555A	Case ref. no:	Y19-0726-FH	Case Officer	Katy Claw
Property Address:	Thornby Farm, Whiteways, Stowting, Ashford			
Proposals:	Erection of a two storey/single storey rear extension together with rear extension together with internal alterations and the addition of three Car parking spaces (<i>Revised proposals</i>)			
Application Type	Planning permission and LBC			
Agent:	Gary Tidwell Associates			
General Comments Operative Conditions?				
Listing / C/A?	Grade II, AONB			
Date Consult Received:	22/07/2019			
Date Comments Sent:	02/01/2020

1- General & Historic Building Description and Significance:

3-Comments:

4-Recommendations:

Elevations as Proposed

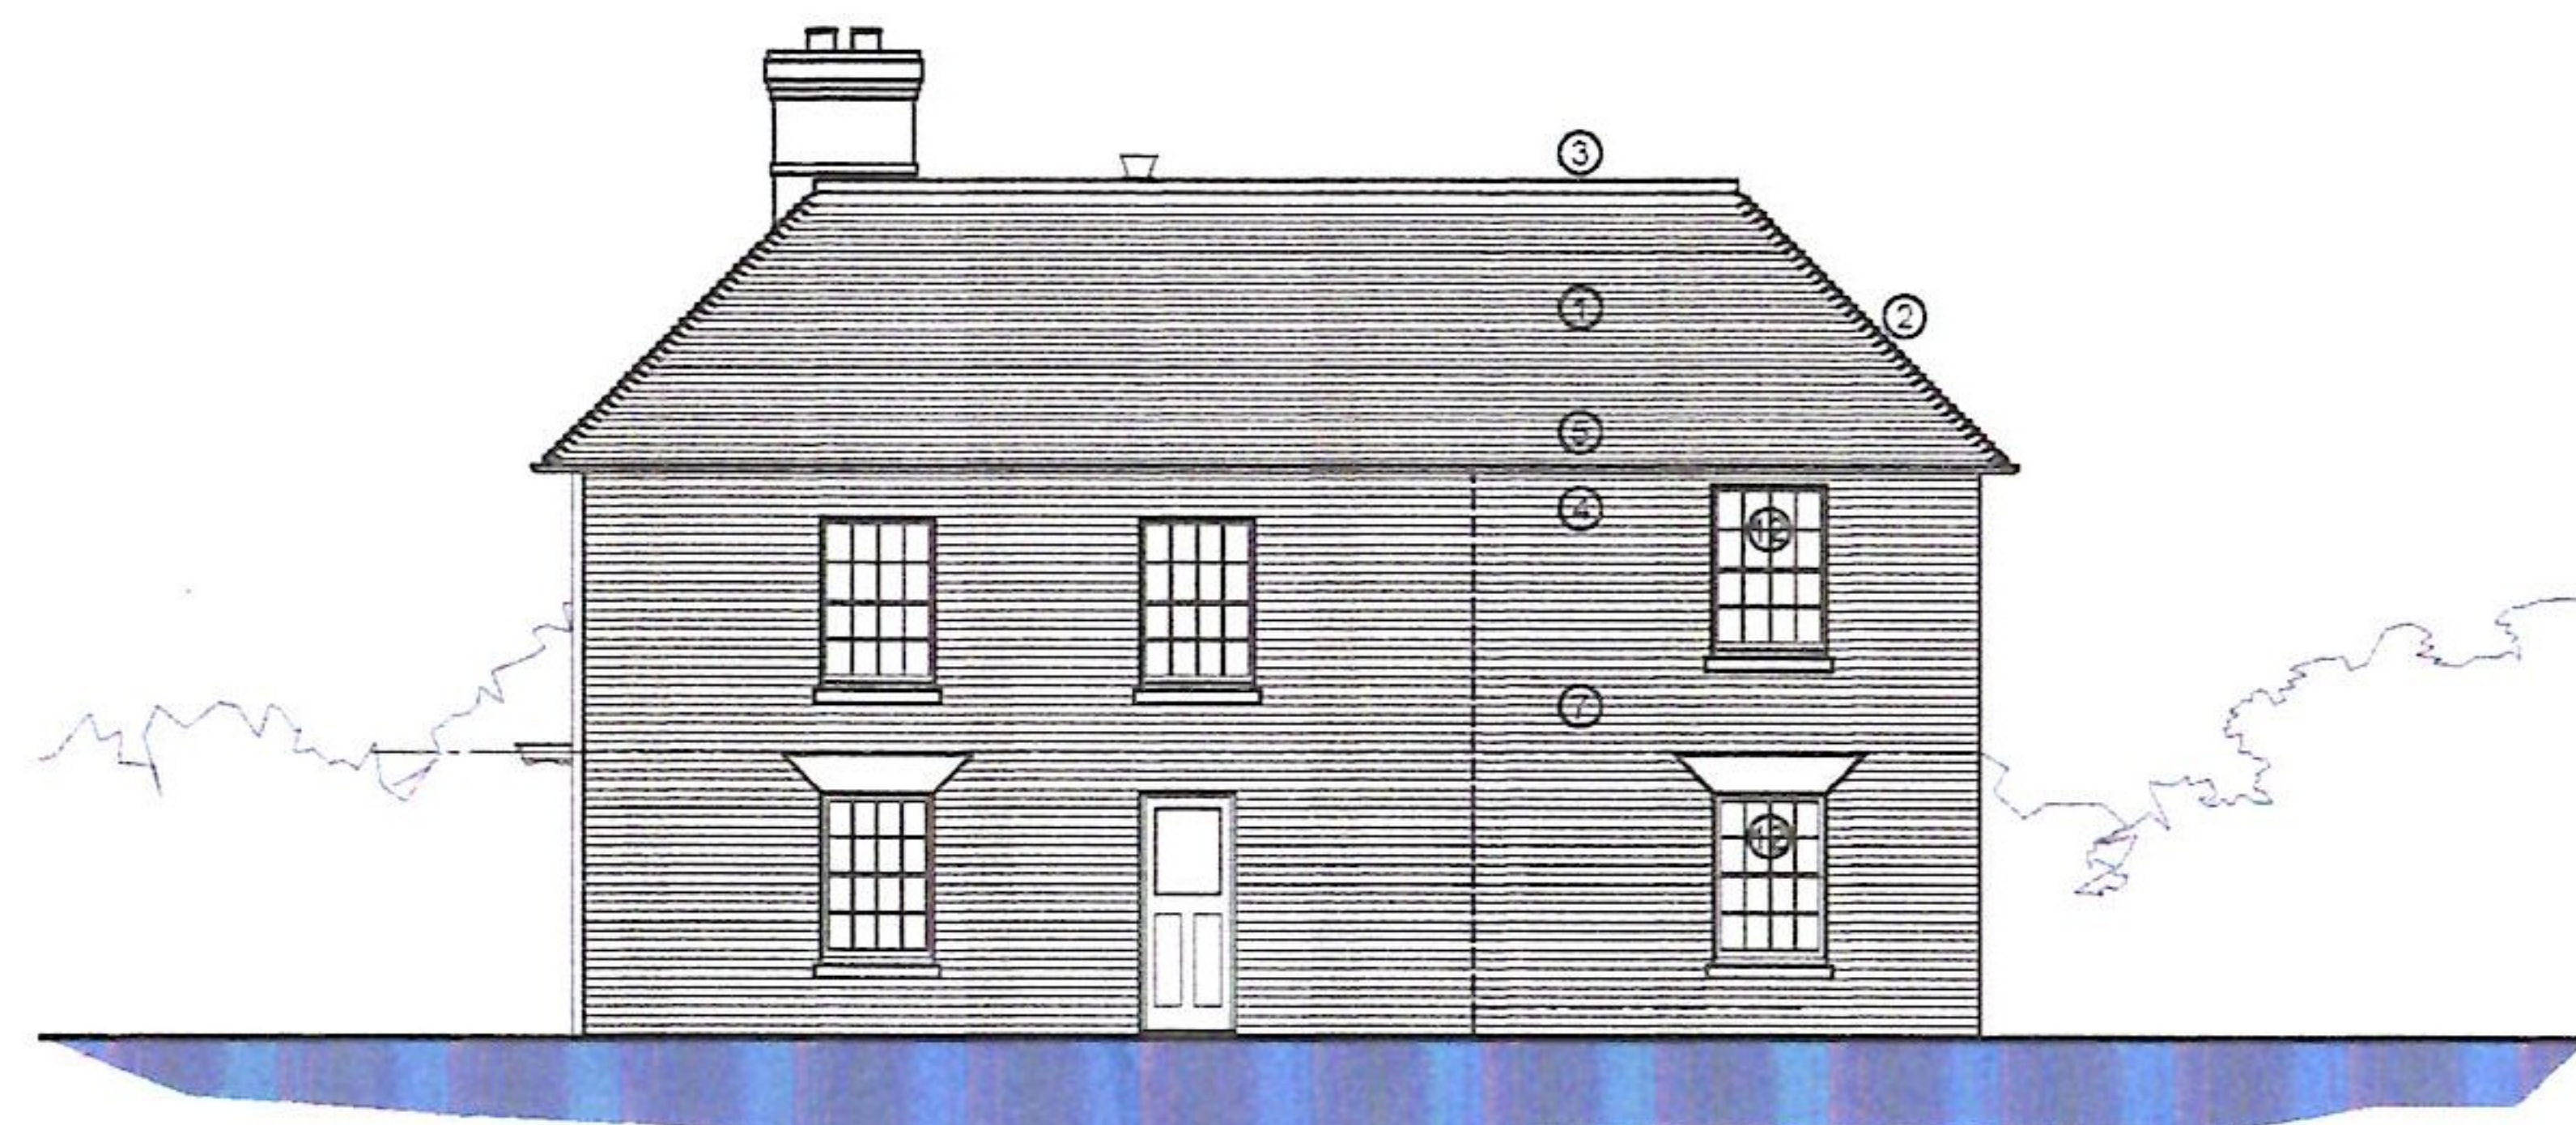
The design of the eastern two-storey extension was previously considered to be acceptable and the minor changes to the fenestration spacing have improved the design and are generally acceptable. The vertical boarded door seems of an inappropriate design for the house and I suggest a more traditional half-glazed door design would be more appropriate (*see enclosed drawing*)

unaltered. The applicant needs to consider how to deal with the scar left by the demolition of the former utility room, which will be left partly exposed, next to the new two storey extension. They might consider forming an additional window here to improve the proportions and provide additional light to the remodelled through living room.

The redesigned kitchen extension is much improved, with the change to brickwork, with sash windows, appearing more appropriate than the previous design. The roof form still appears awkward and it would be preferable if this were changed to a simple ridged hipped roof, omitting the flat roof ridge area. The eaves could be being lowered, set directly above the windows, omitting the brick arches here, so as to reduce the impact of the raised ridge height (as a result of the omission of the flat roofed section)

The retention of slightly more of the rear wall, forming a little nib on the west side is welcomed as this helps to define the position of the original rear wall of the house. This will be further enhanced by having a down stand beam over the room at this point – the drawings do not show this.

The fresh proposal to extend the lean-to storeroom to form a boot room is less successful, with the parapetted flat roof appearing as a rather unsightly “box” on the side elevation. The ground plan of this extension is however ok and I suggest the design could be improved were this element of extension also to have a pitched roof – similar to the kitchen extension and forming a lean to against the west wall of the house at the point where the existing extension is. If the eaves were lowered and the north end of the roof hipped, then this would avoid a clash with the existing first floor bathroom window on the west elevation.

- East extension – amend door design to 1/2 glazed pattern (*see sketch*)
- Centre section – consider how to deal with the scar left by demolished utility room and consider an additional window here
- West kitchen extension – redesign roof as a simple hipped roof with ridge, omitting the centre flat roof area.
Reduce the eaves height by omitting the brick arches over the windows.
Indicate a downstand beam on the line of the original rear wall.
- Side west extension – consider re-designing this with a hipped tiled roof
Consider amending door design to half price (as per extension)
